NID/EJE/L12540-02  
29<sup>th</sup> September 2023

**Burleigh Cottage, Robin Hoods Bay – Planning Ref 2023/0525 & 0527**

Photo 1  
Living room adjacent door to lobby

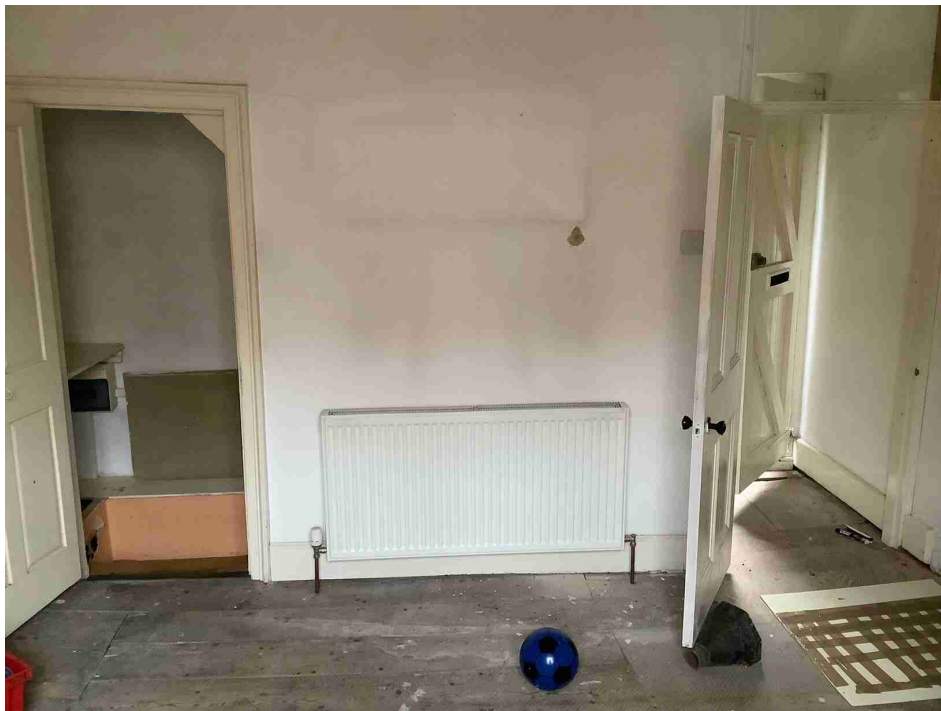
Also attached are photographs of the Living Room floor directly above the Kitchen.

It shows that all floorboards are original and do not have a sign of a trimmed out opening that could provide space for an access stair however small.

There is, as you will note, a small 'hardboard' patch but this is not a size that could be used as access.
